IEEE P802.15
Wireless Personal Area Networks

Project	IEEE P802.15 Working Group for Wireless Personal Area Networks (WPANs)	
Title	TG3 LB19 comment resolution	
Date Submitted	[26 September, 2002]	
Source	[James P. K. Gilb] [Apparent Technologies] [9921 Carmel Mountain Rd. #247, San Diego, CA 92129]	Voice: [858-538-3903] Fax: [858-538-3903] E-mail: [gilb@ieee.org]
Re:	[]	
Abstract	[This document is a record of comment resolutions for LB19.]	
Purpose	[To provide a record of the comment resolution for LB19.]	
Notice	This document has been prepared to assist the IEEE P802.15. It is offered as a basis for discussion and is not binding on the contributing individual(s) or organization(s). The material in this document is subject to change in form and content after further study. The contributor(s) reserve(s) the right to add, amend or withdraw material contained herein.	
Release	The contributor acknowledges and accepts that this contribution becomes the property of IEEE and may be made publicly available by P802.15.

Figure 4—PNC handover MSC

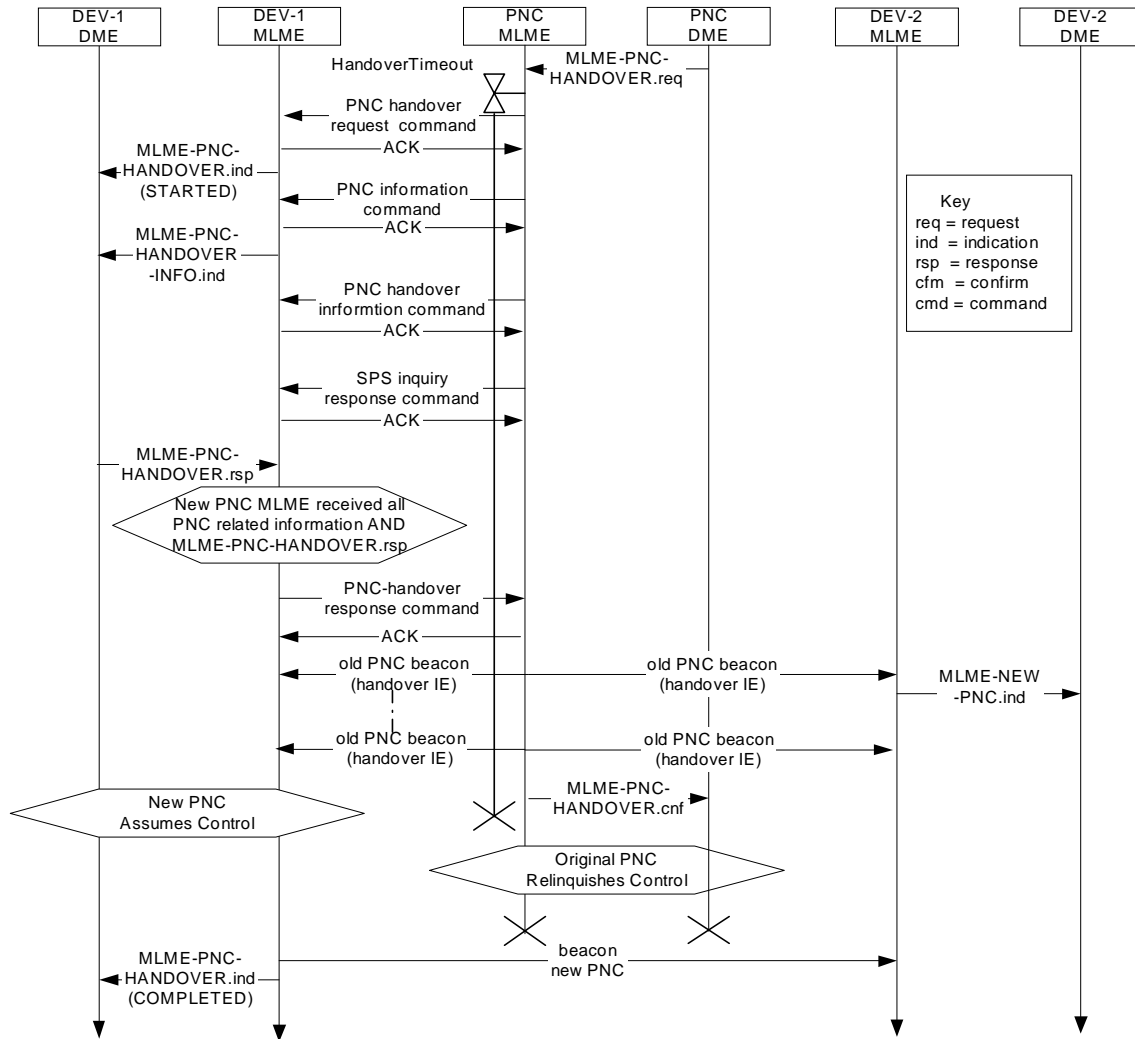
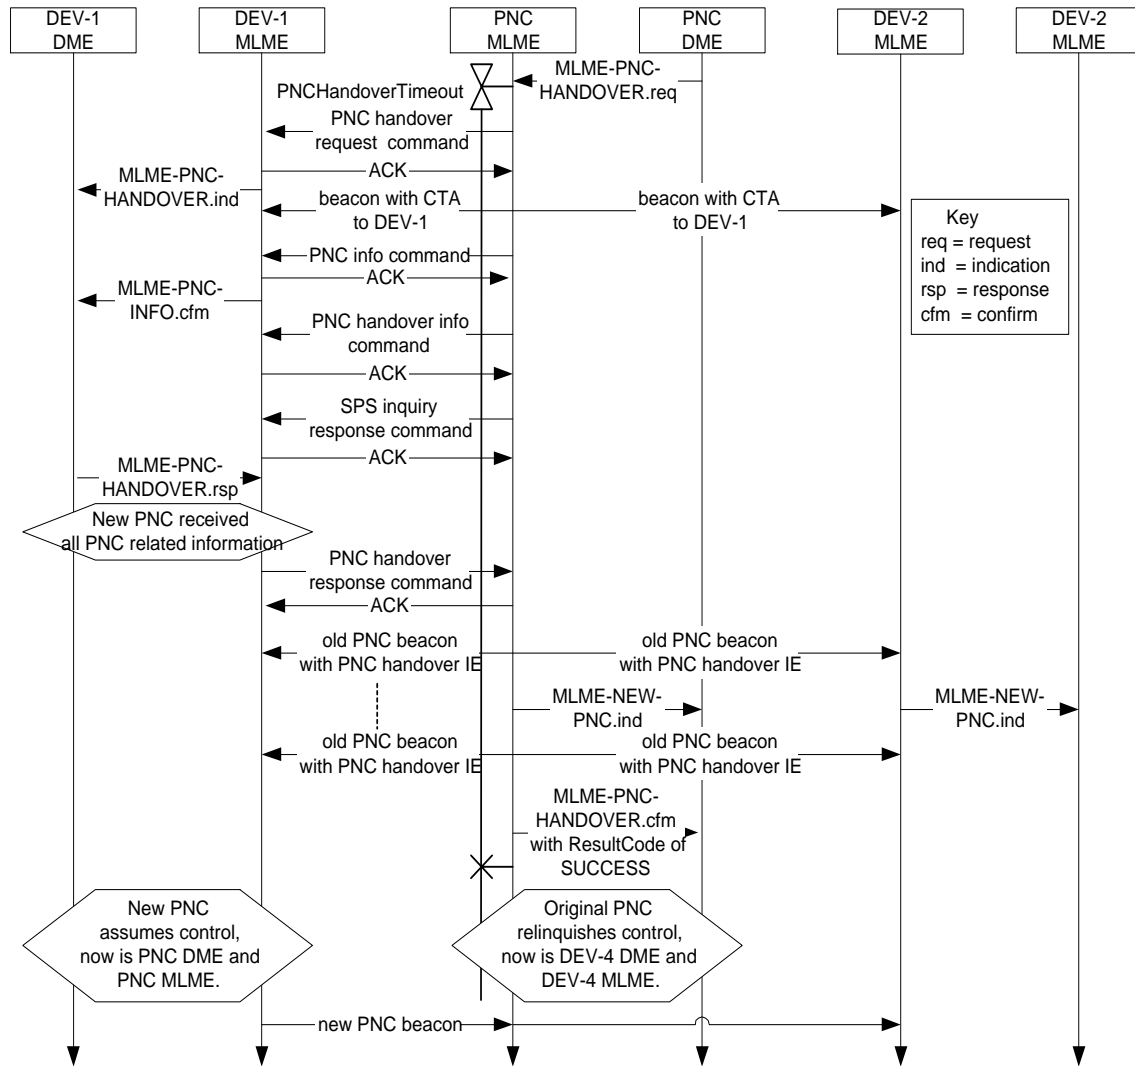
269 (Heberling, TR) - [PNCHndOvr] Some errors in text remain or were introduced after LB17.MSC in Figure 91 is also wrong./KO Text changes for 8.2.3 and ne MSC for Figure 91 are all collected in:02276r7P802-15_TG3-commentsD11_KO.doc, Resolution [03]. **Suggest accept in principle**, “The MSC will be modified as indicated in the resolutions of CID 58 and 232. Make the following text changes: In 6.3.13.4, page 59, line 45, change ‘This primitive informs the originating DME its request for information from the PNC is complete.’ to be ‘This primitive informs the DME that the MLME has received a PNC information command, {xref 7.5.4.2}.’ In 7.5.3.1, page 138, line 20 ‘the number of information records to be transferred using the PNC information command frame(s).’ to be ‘the number of DEV information records, {xref PNC handover info command}, that will be transferred from the old PNC to the new PNC.’ In 8.2.3 PNC Handover, delete page 156, line 8-9, redundant, same text in paragraph below. Add to page 156, line 19, ‘The PNC handover information command shall not be sent if the PNC has indicated in the PNC handover request command that it does not have any CTRBs to transfer.

463 (Gubbi, TR) - Figure-91 is a well done job, but the text needs to supplement some info that can not be expressed in the figure, which is incomplete in the current update to this para. It should be mentioned that these commands shall be sent by PNC even if there is no information present that fits into those commands so that the rx-DEV knows the exact end of the transaction. For example, what if there are no DEVs in power save mode. Still the SPS-inquiry-response-command shall be sent by PNC. It should be mentioned that the three commands in Figure-91 (PNC-info-command, PNC-handover-info-command and SPS-inquiry-response-cmd) shall be sent by PNC even if there is no information present that fits into those commands so that the rx-DEV knows the exact end of the transaction. For example, what if there are no DEVs in power save mode. Still the SPS-inquiry-response-command shall be sent by PNC. **Suggest accept in principle.** "Rather than send the empty commands, the PNC handover request will contain the number of CTRBs and SPS sets that will be transferred. If the number of items is zero, then the old PNC shall not send the command and the new PNC will not expect to receive it. It is not possible for the number of DEVs to be less than 2 (i.e. the old PNC and the new PNC), so the PNC information command will always be sent. This is documented in the resolution of CID 269."

The SPS inquiry response command shall not be sent if the PNC has indicated in the PNC handover request command that it doesn’t have any SPS sets to transfer.’

Add to page 156, line 35, ‘The new PNC shall broadcast its first beacon at the time the beacon would have been sent by the old PNC. This time may vary from the actual time due to clock inaccuracies of old and new PNCs. The new PNC shall start sending beacons with the beacon number counter set to one more than the beacon number of the last beacon that will be sent by the old PNC.’

Add page 156, line 40ff, ‘The PNC shall ensure that the beacon countdown includes at least one system wake beacon and at least aMaxLostBeacons beacons following that system wake beacon. The only exception to this requirement is if the PNC will be shutting down and does not have enough time to to wait for the next system wake beacon to complete the handover process. {Ed. note: This line may be moved to a new 8.1.1 that describes all beacon announcements.’}
